Browns Ferry Nuclear Plant, Unit 2
Renewed Facility Operating License No. DPR-52
NRC Docket No. 50-260

Subject: **Response to Request for Additional Information Regarding Relief Request 2-ISI-28 (TAC NO. ME8779)**

Response to Request for Additional Information Regarding Relief Request 2-ISI-28

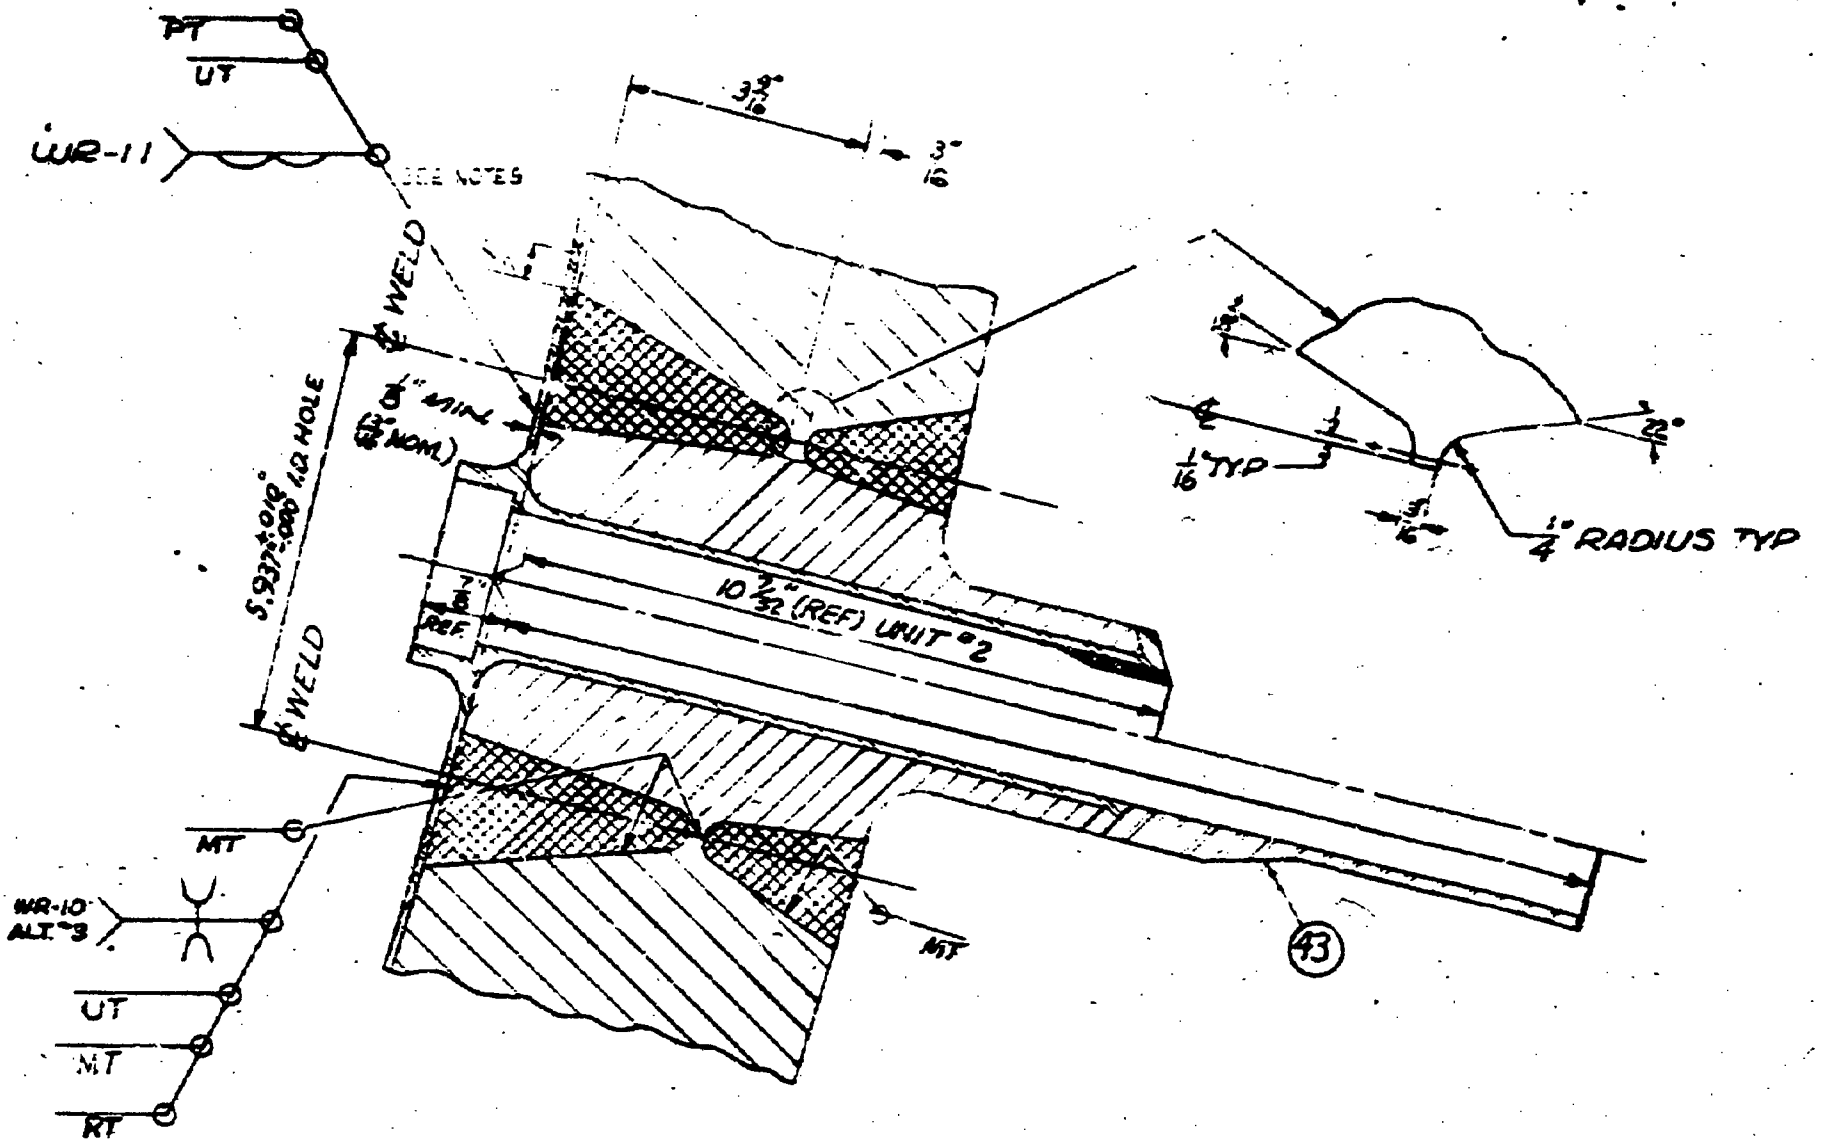
For Weld N10-NV, the calculation for circumferential ultrasonic examination coverage gives a higher weight to the lower 15 percent than the upper 85 percent. From the CDSs, it appears that the Composite Axial plus Circumferential Coverage is 81.7 percent, not 86.2 percent. Confirm that the Composite Axial plus Circumferential Coverage is 86.2 percent. If not, address the discrepancy.

The correct value of the Composite Axial plus Circumferential Coverage is 81.7 percent. The calculation in the examination report determined the percentage of coverage obtained. But, during calculation of the circumferential coverage of the upper 85% of thickness (T), the calculation did not include the appropriate weighting factor of 85% (0.85). The value should have been multiplied by 85% (0.85) prior to composite. This error has been entered into TVA's Corrective Action Program.

Detail B, Drawing 151863E, Modification of 2" Liquid Control Nozzle

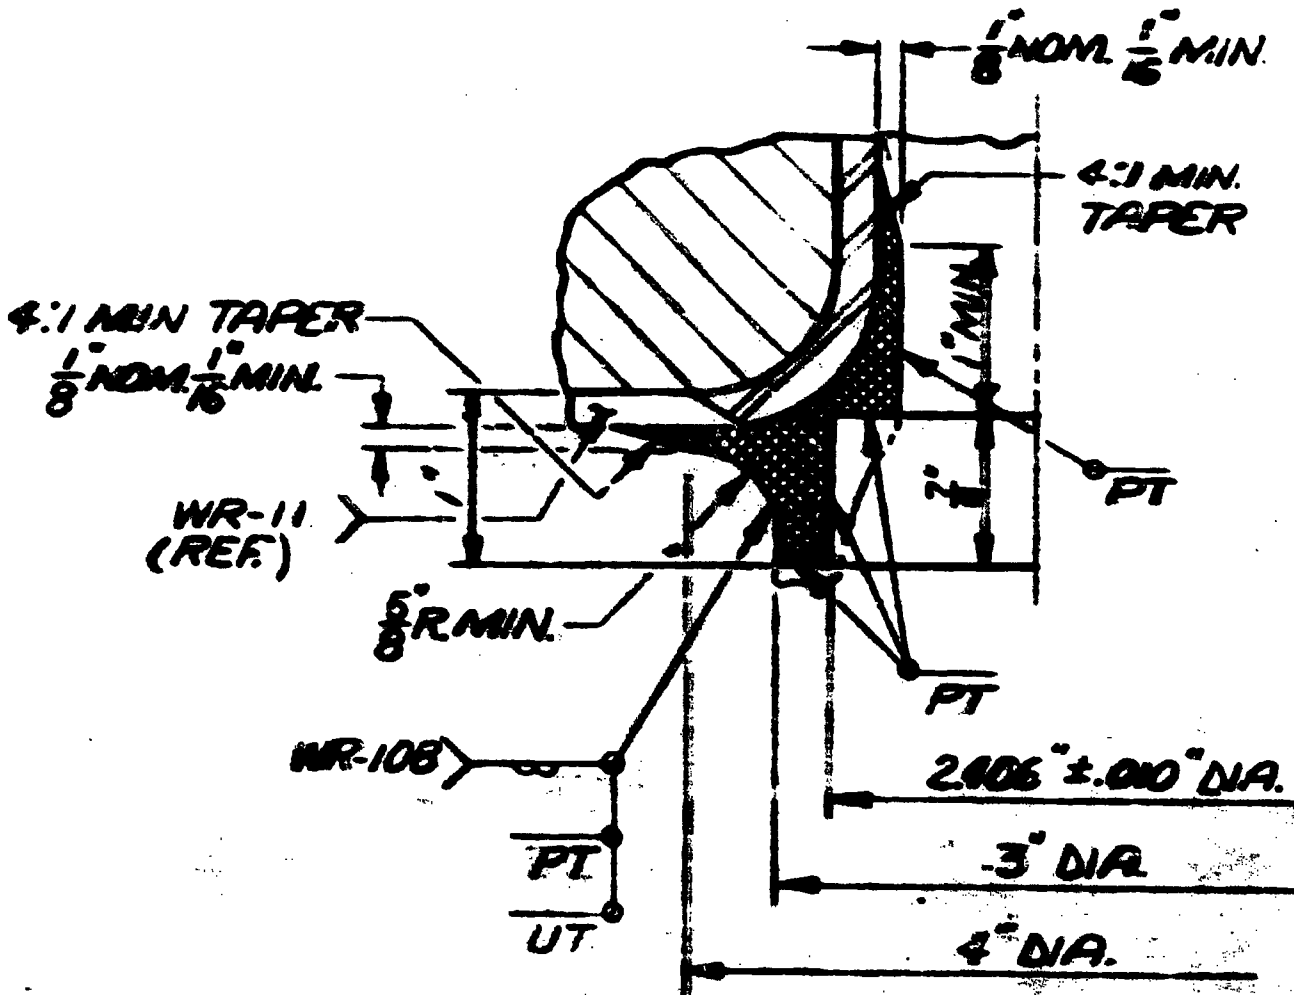
The Table on page E-6 indicates that the request is for two welds. For each sketch provided, identify the weld(s) that relief is being requested by using standard American Welding Society weld symbols pointing to each weld face to identify that weld. If a weld face contains more than one weld designation, identify this on each sketch

Request for Relief 2-ISI-28 requests relief from weld examination coverage requirements for one reactor pressure vessel nozzle-to-vessel full penetration weld and nozzle inside radius section. Attachment 1 shows the nozzle to vessel weld (N10-NV), including the requested weld symbols. A built up pad machined to form a socket for connection of Standby Liquid Control (SLC) piping is present on the inner radius of the nozzle forging. Details of the inner radius configuration are provided in Attachment 2.

Figure 4. Browns Ferry Standby Liquid Control Nozzle (N10): Probe Scan Limits and Examination Coverage for Vessel Shell Detection Technique, 70/(2 to 23)v.

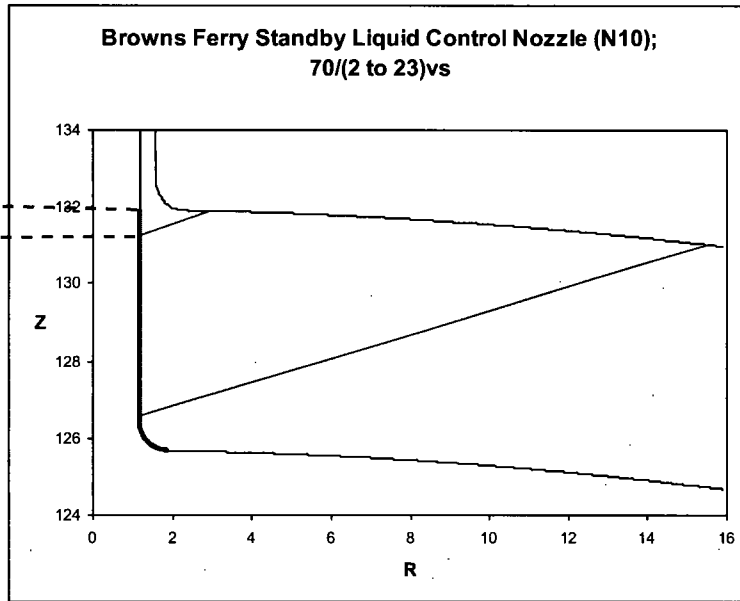
Address how the coverage for the N10-IR inner radius examination was calculated. Provide a coverage map showing the areas that were missed.

Modeling report IR-2004-43 was developed by the EPRI NDE Center. The essential geometric parameters of the Browns Ferry Standby Liquid Control nozzle and the qualified procedure essential variables were input into the EPRI software to calculate the coverage obtained. Attachment 3 provides the coverage map for the limited volume of coverage.

Figure 4 shows the minimum and maximum probe radial positions and the portion of the examination volume covered by the vessel shell detection technique, 70/(2 to 23)v, for probes scanned at the azimuth angle of 0°.

The bold line area between the dotted lines represents the non inspected area.
